**COMMONWEALTH OF KENTUCKY
BEFORE THE PUBLIC SERVICE COMMISSION**

ELECTRONIC 2023 INTEGRATED)	
RESOURCE PLAN OF BIG RIVERS)	CASE NO. 2023-00310
ELECTRIC CORPORATION)

**COMMENTS OF JOINT INTERVENORS
KENTUCKIANS FOR THE COMMONWEALTH AND KENTUCKY RESOURCES
COUNCIL**

Report on Big Rivers Electric 2023 Integrated Resource Plan

Figure 2 – Residential Revenue per MWh in Kentucky²³

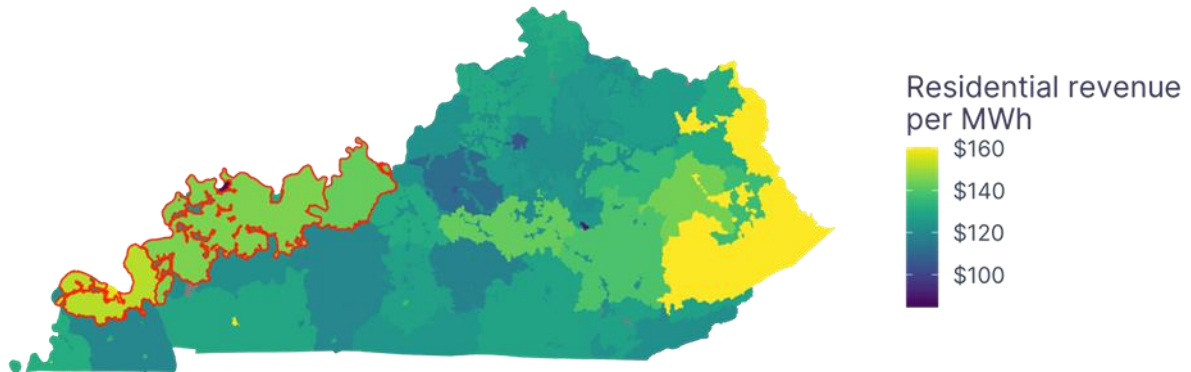
for residential customers in Big Rivers’ service territory – especially those served by Jackson Purchase and Kenergy – were exceeded in Kentucky only by those in the eastern part of the state, as shown in the following map, highlighting Big Rivers’ members’ territory in red:

the highest. This trend raises significant questions, mostly unaddressed by Big Rivers, about whether a largely status quo resource plan such as that presented in the IRP is reasonable.

Figure 6. MPS Technical Potential Comparison

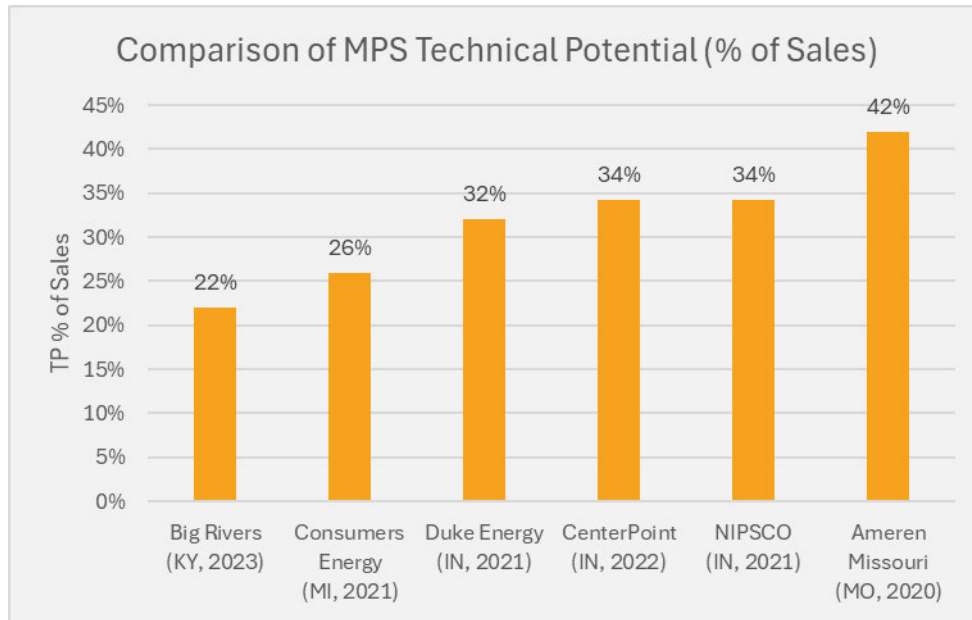
The definition of technical potential generally does not differ across studies, and technical potential is not affected by inputs such as avoided costs or incentive levels. Therefore, comparing technical potential across jurisdictions is a reasonable way to benchmark studies. Figure 6 shows the technical potential, as a percentage of sales, for Big Rivers and five geographically similar electric-only market potential studies. Big Rivers is the lowest, at 22% of sales.

The comprehensiveness of measures analyzed in an MPS has a direct impact on the overall technical savings potential. According to ACEEE, “Technical potential is limited by the types of commercially available and emerging technologies that the analyst or commissioning entity includes in the analysis.”⁸⁵ As noted above in Figure 5, the Big Rivers MPS has the least comprehensive measure list, which contributes to the lowest technical potential among geographical similar jurisdictions shown in Figure 6.

programs between 2012 and 2019, and only one minor program since then.⁸⁷ It stands to reason, therefore, that the Big Rivers service territory would have more technical potential remaining than Consumers Energy, yet as shown in Figure 6 above, the MPS found the opposite.

Figure 7. MPS Economic Potential Comparison

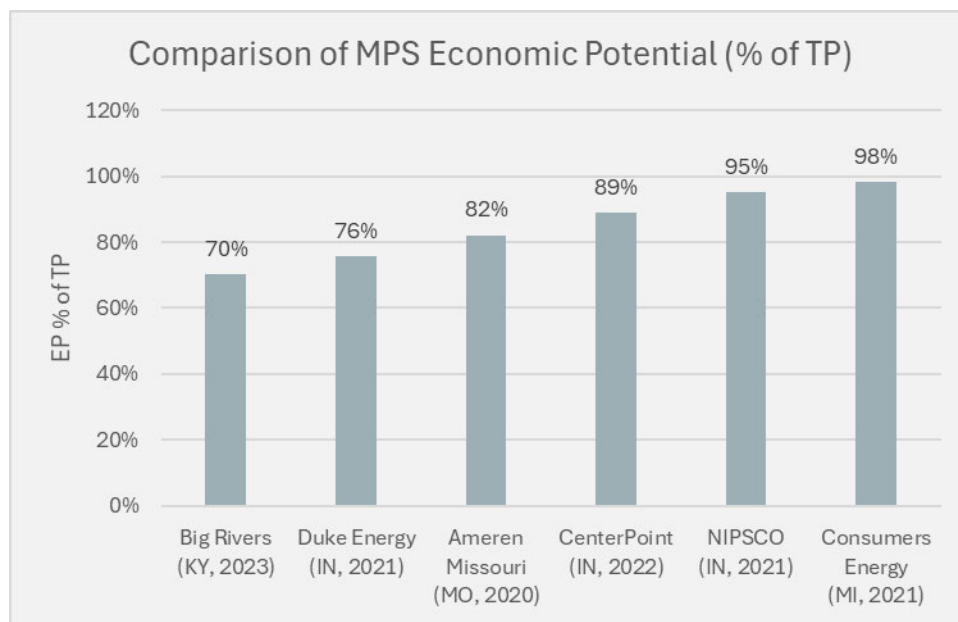
In excluding the benefits of avoided T&D costs and increased resiliency, and failing to consider significant external funding sources, the Big Rivers MPS analysis quantified inappropriately low benefit-cost ratios (“BCRs”). As a result, some measures may have been improperly excluded from the study, and the portfolio of measures in the Achievable and Program Potential scenarios will reflect artificially low cost-effectiveness scores.

When compared against geographically similar electric-only market potential studies, the Big Rivers MPS shows the lowest level of Economic Potential as a percentage of Technical Potential (70%, Figure 7). This finding means that Big Rivers is screening out the largest amount of savings between Technical Potential and Economic Potential. Clearspring’s omission of avoided T&D, resiliency, and failure to account for external funding are contributing factors to this outcome.
